PLANNING BOARD REPORT PORTLAND, MAINE

Seaport Lofts (Bay House Phase II)
101-121 Newbury Street and 40 Hancock Street
Level III Site Plan and Subdivision Review
2013-179
113 Newbury Street, LLC, Applicant

Submitted to: Portland Planning Board	Prepared by: Nell Donaldson, Planner
Public Hearing Date: September 24, 2013	Date: September 20, 2013
Planning Board Report Number: #42-13	CBLs: 20-D-13, 14, 15, 32

Figure 5: Proposed Hancock Street elevation

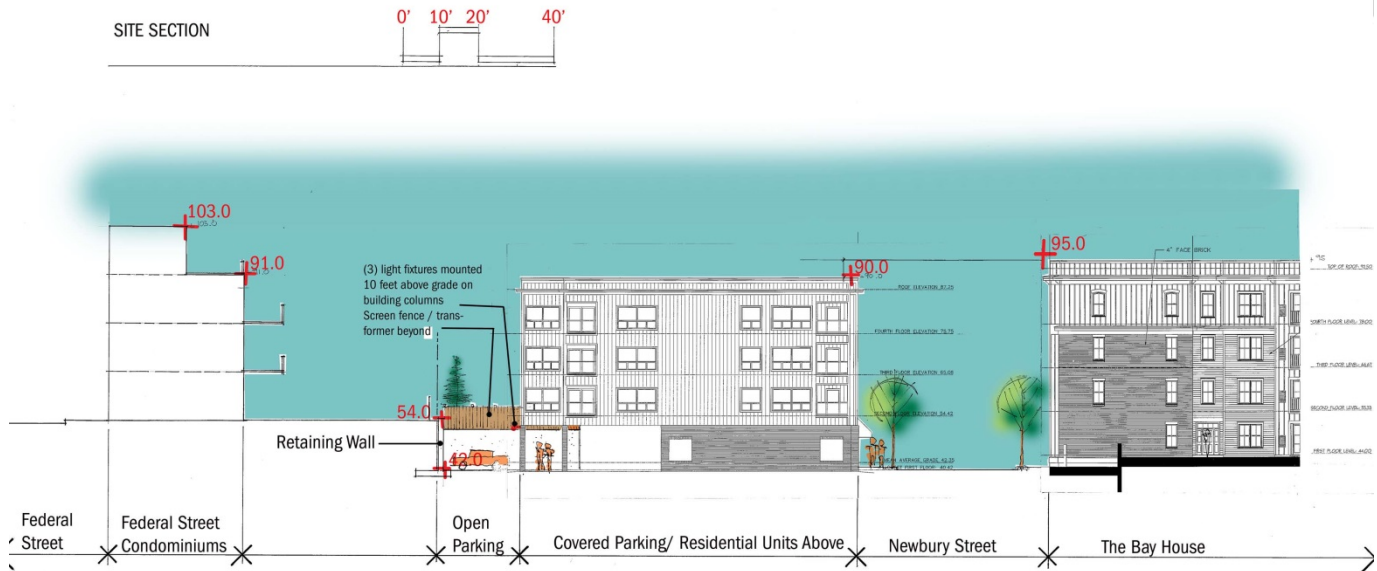
Figure 5 below shows the proposed Hancock Street grade elevations. Much of the shadow impact from the Seaport Lofts would fall on the northerly residential buildings, although this would be mitigated slightly by the elevation change toward Federal Street. There would be no shadow impacts to publicly accessible open spaces. Per the Technical Manual, a shadow study is not required for Level II or III developments that are less than 45 feet tall (*Section 11.3*). Though the height remains to be verified by the zoning administrator, it is the applicant’s intent that the building meet the zoning height limit.
